## Development Permit Panel

Wednesday, May 30, 2018  
3:30 p.m.

1. **DEVELOPMENT PERMIT 17-772227**  
(REDMS No. 5727636)

PROPERTY LOCATION: 11671 and 11691 Cambie Road

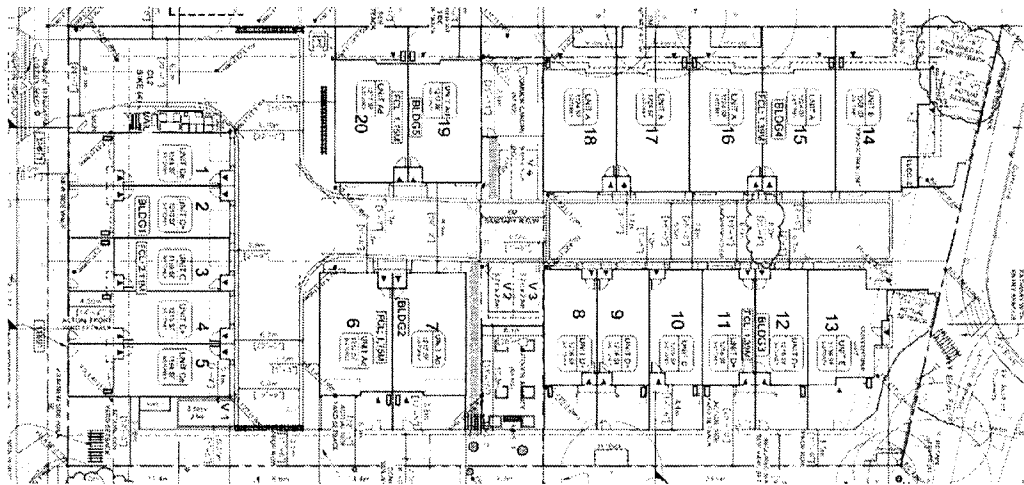
- consider a similar treatment along the east edge of the internal drive aisle;

*Have done this. Site entry pavers extended to SROW, linking to PROP walkway.*
